REQUEST FOR TECHNICAL CHANGE

AGENCY: Building Code Council

2017 NC Electrical Code
Table 300.5 Minimum Cover Requirements. (180612 Item B-11)

**FIGURE AM109.1(2)
KNEE BRACING**

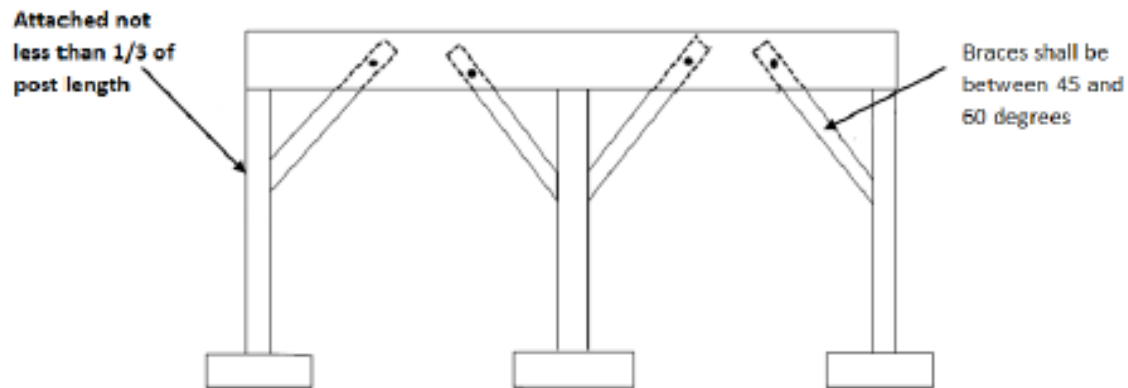
I am just asking – in Figure AM109.1(2), will the text boxes about Freestanding Decks and Decks attached to the structure that were published in the Register, as well as the footnote of conversion, be included in the Code? I realize that it may be hard to recreate these for the RRC submission, but I did want to know if you intended to include them or if they were not adopted as part of the amendment.
